California Energy Commission DOCKETED 12-AFC-03 TN # 69054 JAN. 08 2013

# AES Redondo Application Data Adequacy Assessment

Submitted on Behalf of the Residents of Redondo Beach and Hermosa Beach

Figure 2: Oblique view of AES site shows how any 85 foot facility would dominate the surrounding uses.

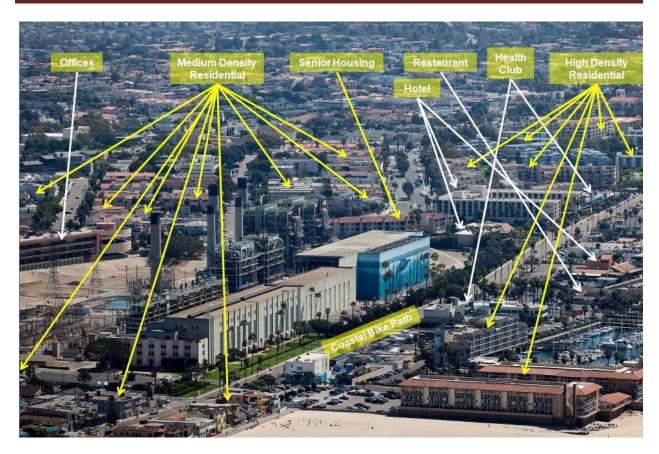
Figure 2 gives a better perspective of the site and its close proximity to incompatible uses. There is no denying that an 80 foot high power plant anywhere on this site will have a dominant and unavoidable negative impact on all the surrounding uses. While AES tells the public the plant will be hidden from most views, the site and proximity make this impossible.
